THE CLEVELAND ELECTRIC ILLUMINATING COMPANY

Perry Nuclear Power Plant
Docket Nos. 50-440; 50-441
FSAR Chapter 12

This letter and its attachments are provided to identify the basis for the changes and clarifications made to FSAR Chapter 12 in Amendment 20. Additionally, further clarification is provided on the description in Section 12.5 on the Shop Facility Decontamination Area.

Figure 7-3

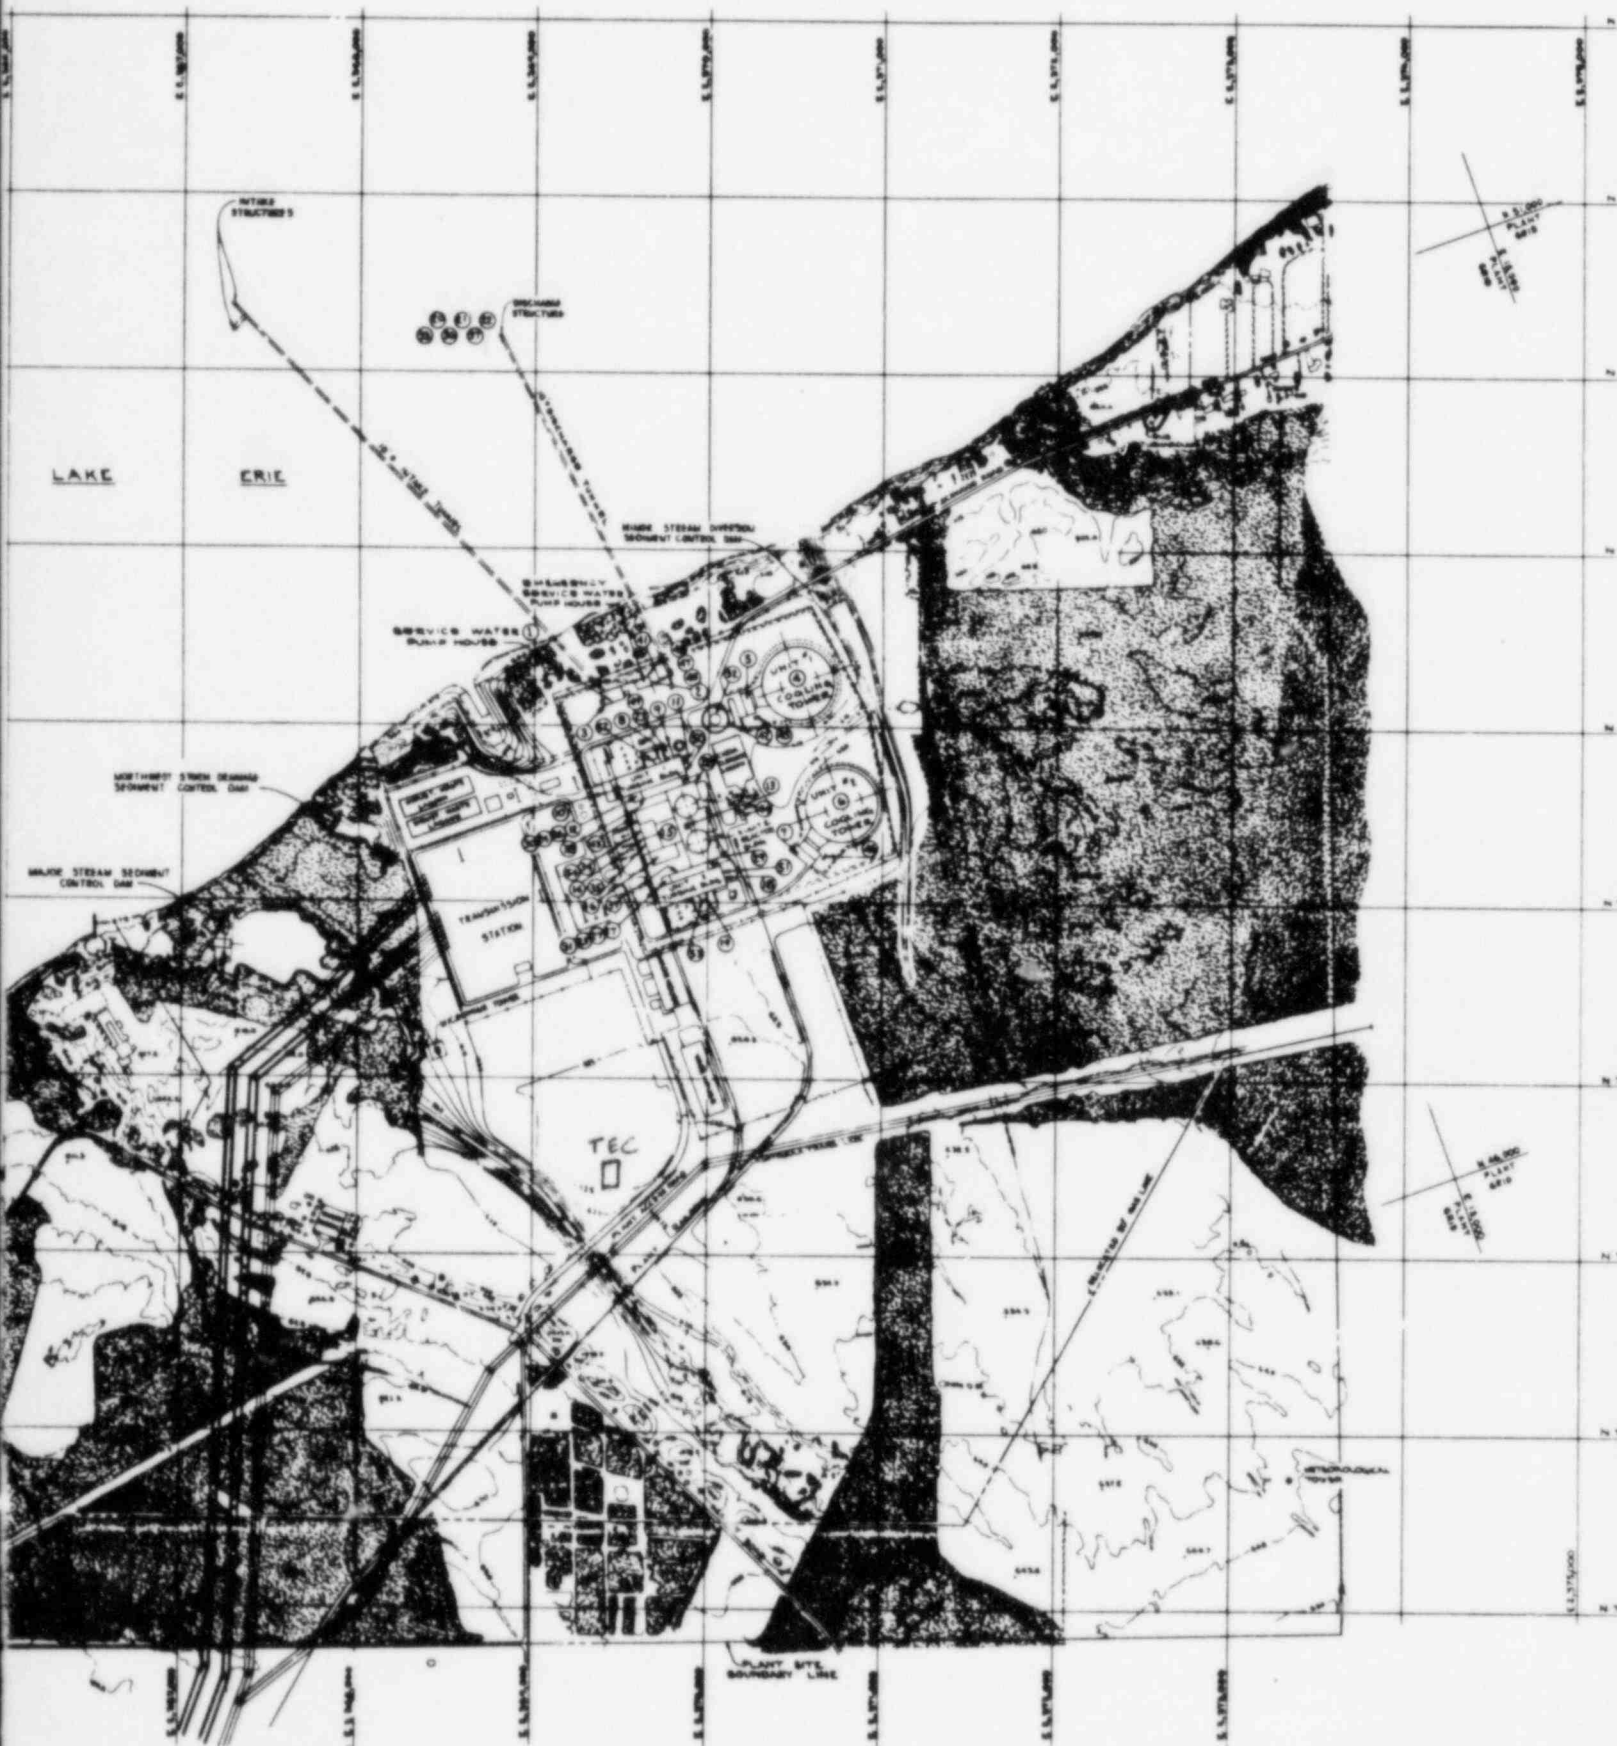
The EOF has been sized to provide adequate space to perform all required functions including space for designated Federal, State, and Local officials which may be sent to the EOF. There is a personnel decontamination room in the EOF for decontamination of site evacuees should it be necessary. The General Employee Training room on the second floor of the Training Center can be used for conducting small news media briefings. The layout of the EOF is shown in Figure 7-3.
